M  
E  
M  
O

Project: Clear Space Theater

Topic: Property Noise Level Study - Additional Comment

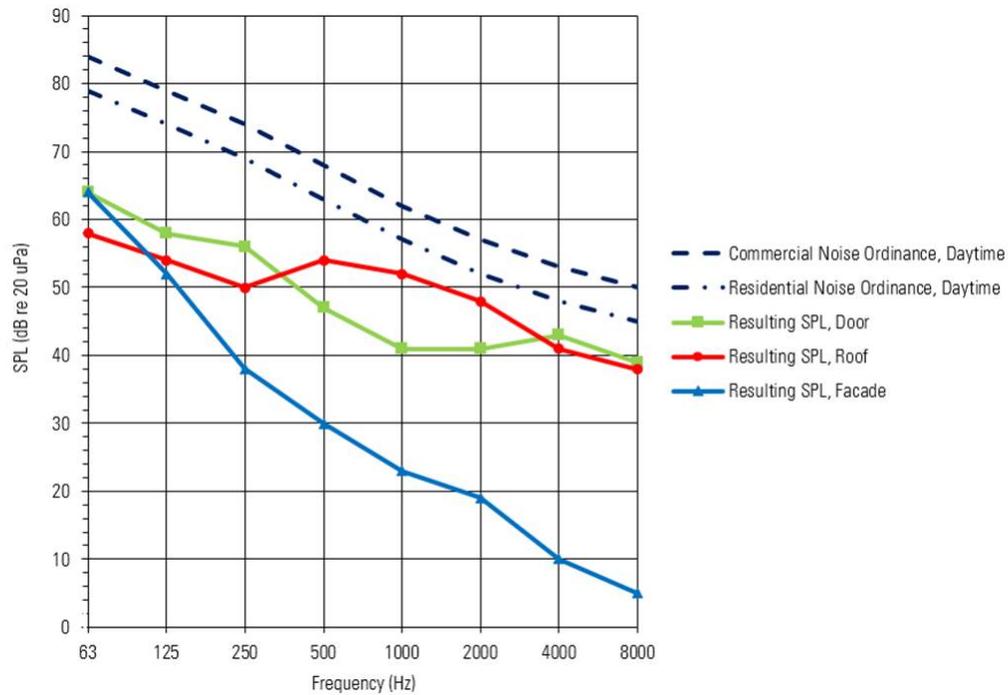
We appreciate Mr. Everbach's observation that the residential noise levels govern in the case of this site, and we have added the Residential reference line on our graph accordingly.

For predicted levels resulting from roof construction, we have only considered attenuation by distance - as if all noise from the roof were emitted right at the north edge of the roof. We thus ignored the beneficial effects of the parapet in directing sound upward and away from the residential properties and also ignoring that the roof most efficiently radiates sound upward, perpendicular to the roof plane rather in-plane with the roof deck. The calculations presented in our graph are indeed conservative. Please see the Recommendations section below for further discussion.

With the above as context, we remain confident that our calculations of likely sound pressure levels are appropriate to the circumstances and that peak levels resulting from 95 dB peak sound levels inside will be 5 dB or more below the residential daytime maximums in the Ordinance.

In response to Clear Space's request that we investigate ways of improving the acoustic performance of the building enclosure, we turned our attention to the doors and the roof construction since the façade construction performs quite well in the predictions. We can offer the following recommendations to increase the factor of safety:

- Change the two exterior doors to ones carrying an acoustic rating of STC 45 or higher.
- Add a layer of exterior gypsum sheathing to the roof system.

These two changes to the design will move the resulting peak noise levels at the residential property line still further below the required levels in the Ordinance as shown on the graph below.

The graph below indicates the predicted levels resulting from the improvement to the doors and roof construction.
